# SUBSURFACE WASTEWATER DISPOSAL SYSTEM APPLICATION

REPLACEMENT SYSTEM VARIANCE REQUEST

GENERAL INFORMATION
Town of X Portland Maine
Permit No. 10004
Date Permit Issued
Property Owner's Name: Jayne Newirth
Tel. No.:
System's Location: Cliff Island
Property Owner's Address: 23 Windpath East
(if different from above) West Springfield, Mass 01089

EDGE OF LEDGE OUTCROP  
 TOP OF LEDGE ABOUT 600 TO 6" GRASS SURFACE  
 JANE NEWITH  
 CLIFF ISLAND  
 1" = 100'  
 PROPOSED LEACH FLD.  
 EXISTING TANK  
 APPROX. EDGE OF STEEP BANK

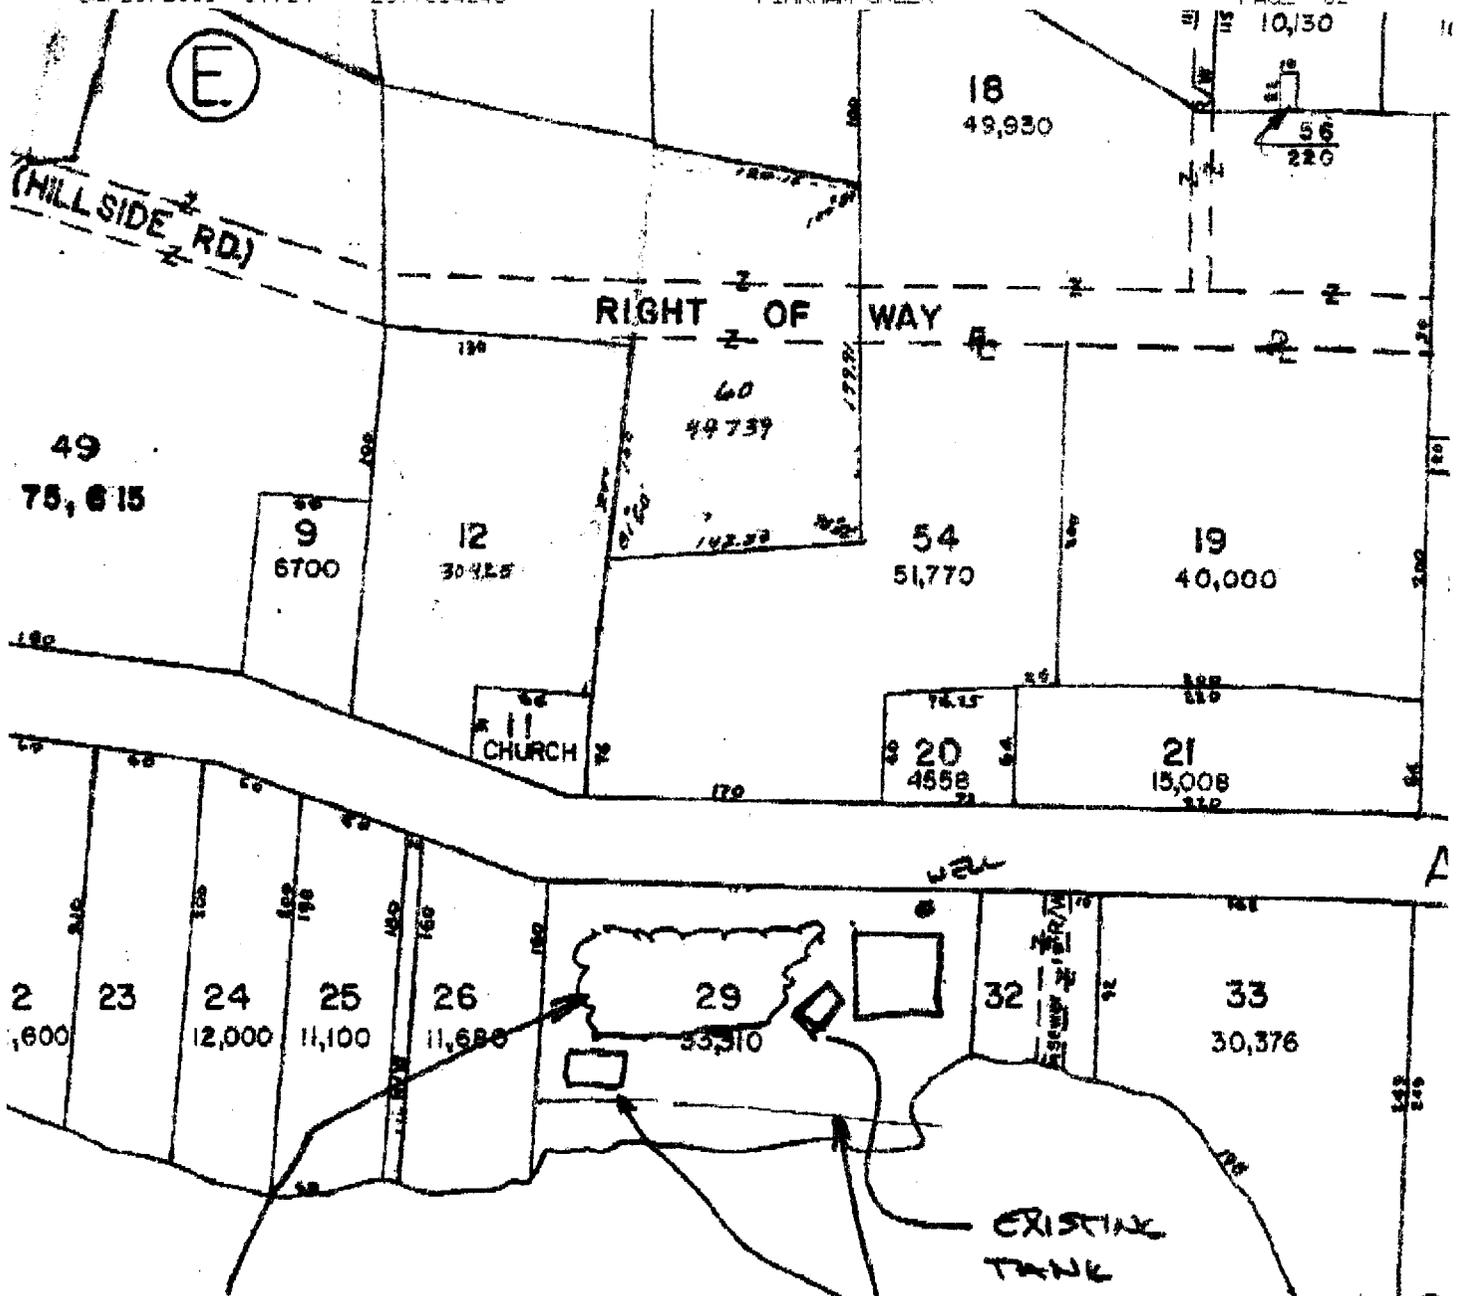
ATTACHED IS JANE NEWITH LOT WITH LEDGE OUTCROP DELINEATED - THIS IS LEDGE AT OR NEAR THE SURFACE I 6" SOIL DEPTH THERE IS A SMALL TERRACE WHERE I HAVE DESIGNED THE SYSTEM THAT HAS THE ONLY SIGNIFICANT AMOUNT OF SOIL ON THE LOT.

Can't get setback, needs A 29' variance  
 6" in depth of ledge
